Service Information

| Category R | Technical | Ref. No. E010/13A | Page 1 of 1 |
| Applicable Model CX-5(KE), Mazda6(GJ), Mazda3(BM) | | Applicable Countries or Specifications Worldwide | |

Subject: Stabilizer Bush of Front and Rear

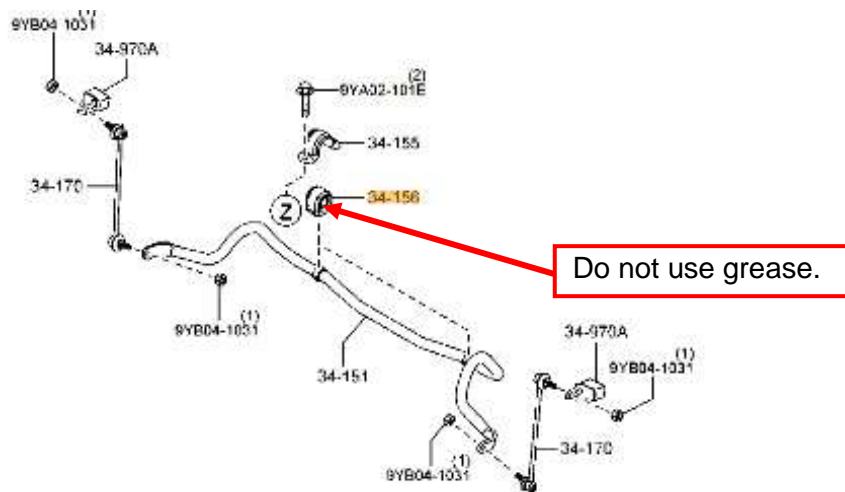
To prevent noise from stabilizer bush, do not apply grease on the bushes of front and rear stabilizer. (Example below shows CX-5 front stabilizer bush)

For the newly developed models from CX-5, grip type bushes are installed to prevent noise. If you apply grease mistakenly, a noise due to slipping may occur. Therefore, please do not apply any grease to the bushes of front and rear stabilizer.
